RE: Clause 23(1) Resource Management Act 1991 Further Information – Private Plan Change request by Campana Land Owners Consortium

Thank you for the private plan change request to rezone land at Campana Road, Puhinui. A plan change number will be allocated at formal notification stage. Please advise whether you wish to have a particular plan change title.

Planning Matters (Council Specialist Peter Reaburn)

Figure 1c: Shows the indicative line of MHWS in the thick blue dashed line. The green line (immediate to yellow line) shows the extent of the area susceptible to coastal erosion and instability to 2130 under the RCP 8.5 scenario.

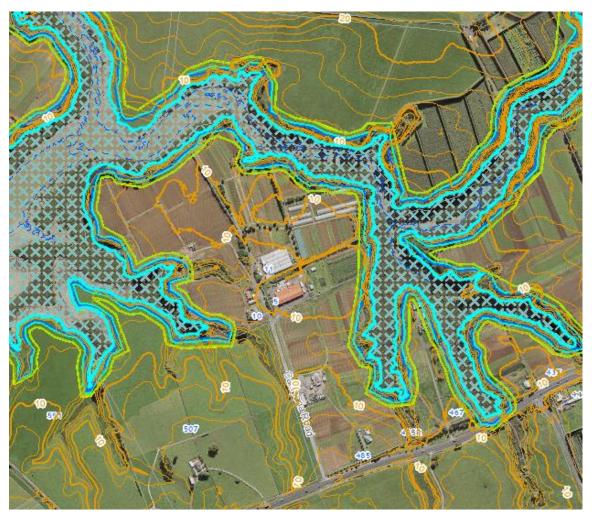
Auckland Council has undertaken a regional assessment of the area susceptible to coastal instability and erosion (ASCIE) in the Auckland Council Technical Report 2020/021 'Predicting Auckland's Exposure to Coastal Instability and Erosion". The regional scale scenarios for the Proposed Plan Change site are given in Figure 1c below.

As the site is within CEHA, this would trigger consent for buildings/structures under Chapter E36 and under Chapter E38 for subdivision in the AUP. Under s106 of the RMA relevant matters to the proposal are the AUP provisions that establish the coastal erosion hazard area (CEHA) and the Council's Areas Susceptible to Coastal Instability and Erosion (ASCIE).

Campana Road Structure Plan

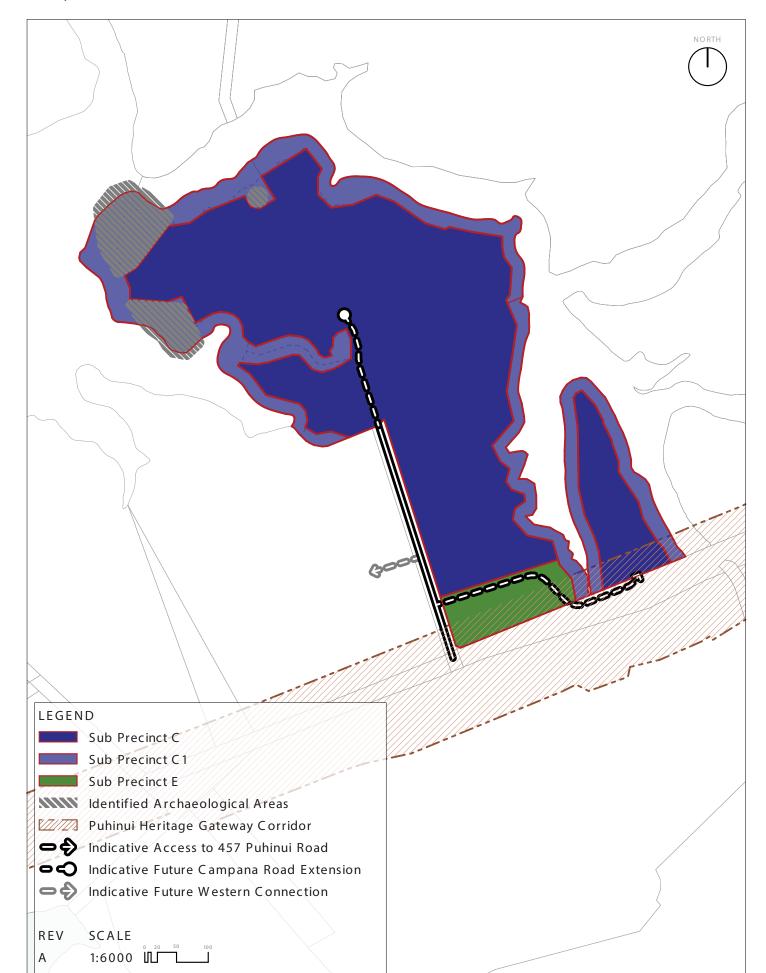
A "Campana Structure Plan" is referred to in the amended PPC provisions, however it is not part of the provisions. It is therefore unclear, in the provisions, as to what that structure plan is or what part it plays in the management of the area. Reference to a Campana Structure Plan either needs to be deleted or made more transparent through provision of the structure plan and means by which the structure plan elements are to be taken into account in future development.

Please clarify the purpose and intent of the Campana Structure Plan in the proposed PPC provisions.

Please identify archaeological sites R11/3513 and R11/1112 on precinct provision map "I432.10.5. Puhinui: Precinct plan 6 – Campana Road Structure Plan".

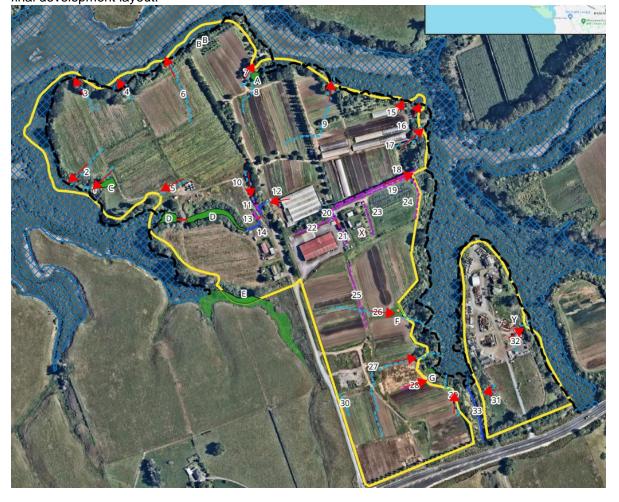
- · provide a plan to show indicative layout of the proposed public stormwater network.
- provide a plan to show post earthworks overland flow paths and areas that will have ponding of water with a flow rate of over 2m³/s.
- provide the indicative number and location of private and public coastal/stream outfalls intended to serve the proposed plan change area.

We expect the indicative outfall locations to be as shown by the red arrows (20 locations) below on the
extract of Appendix B from Viridis Ecological Impact Assessment to the modelled OLFP's and
intermittent drains. Although this will be subject to a detailed design process based on determination of
final development layout.

Figure 5: Excerpt of the Auckland Coastal Instability and Erosion Map

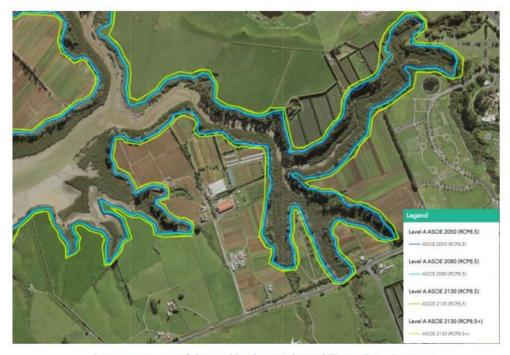
The Applicant's Geotech Appraisal Report (page 12) states "...... Future erosion predictions for the 2130 RCP8.5 scenario suggests ~20m of land loss (approximately measured back from current slope crests) is possible (Figure 5)". Regarding sea level rise scenarios, the IPCC's 6th Assessment Report (2021–22) adopted a new core set of future representative scenarios, based on Shared Socio-economic Pathways (SSPs). There has been a transition from the previous representative concentration pathways (RCPs) to SSP scenarios. The Council's regional ASCIE forecasts were based on RCP scenarios. Further, the ASCIE projections did not include VLM which has a direct impact on the local sea levels along New Zealand coastlines.
